AMBASSADOR CONSTRUCTION CO., INC.

RE: Mayor's Office of Emergency Management
7 World Trade Center - 1, 7 & 23rd Floors
Change Order #077
Amb. Job # S57-5175

Job Title/Working Title
MAYORS OFFICE OF EMERGENCY MANAGEMENT
PENTHOUSE ELEVATION & EXTERIOR DETAIL

Scale
AS NOTED
Drawn By
17-01-00
Job No.
FSK-52
45754

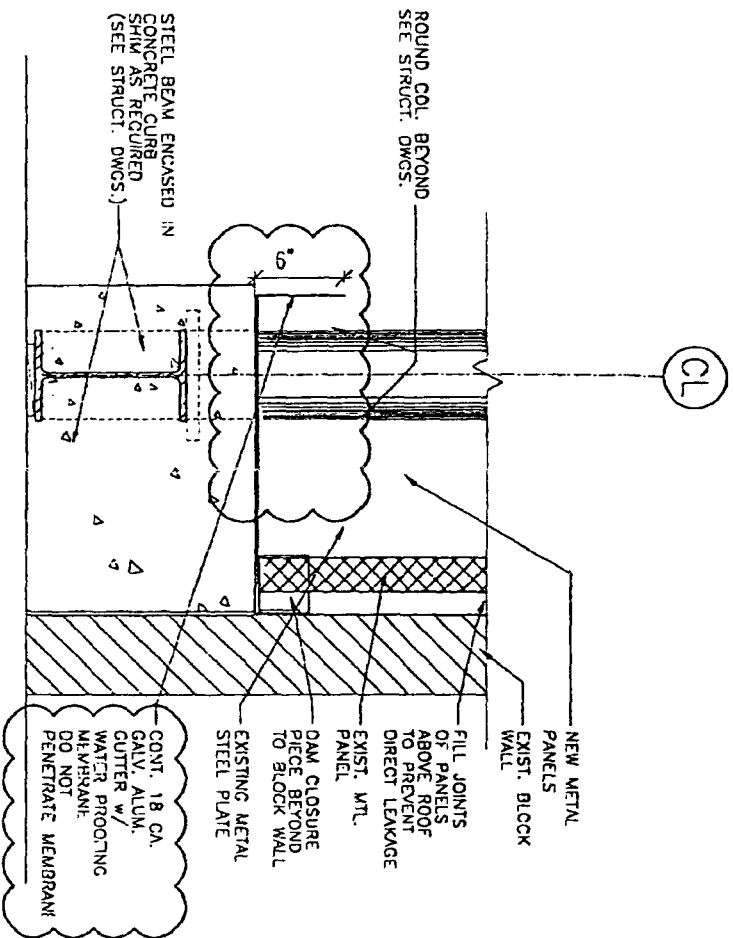
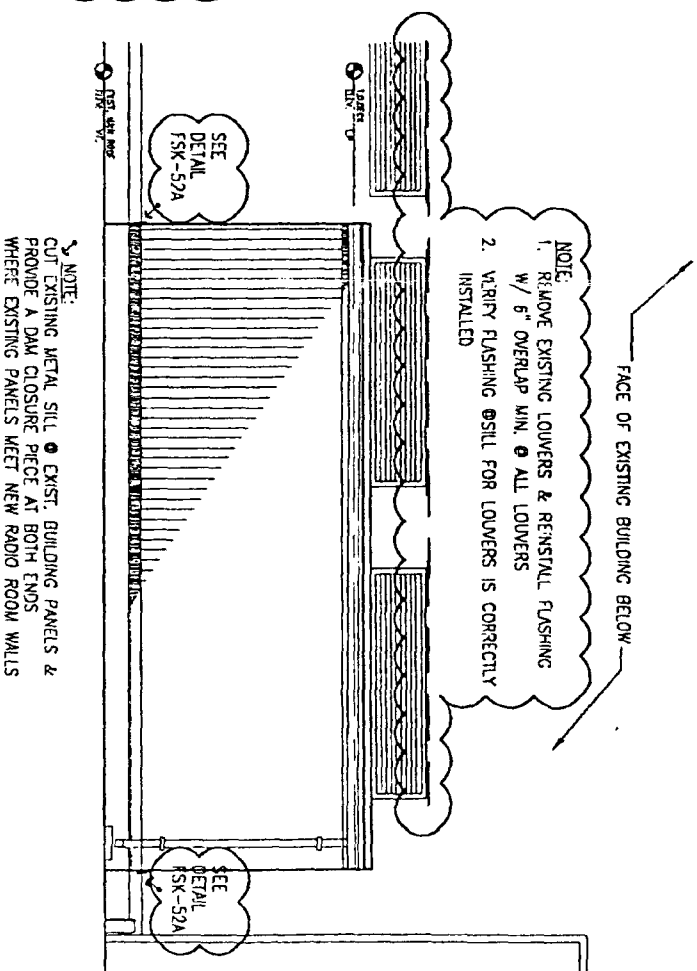
- Furnish and install two (2) aluminum dam closures where new panel walls abut existing wall system.
- Remove existing louver and install continuous flashing and re-install louvers.
- Furnish and install all aluminum drip pan @ back concrete curb.

Additional flashing details as per Swanke Hayden Connell's office sketches 52 and 52A dated 1/29/99 attached.
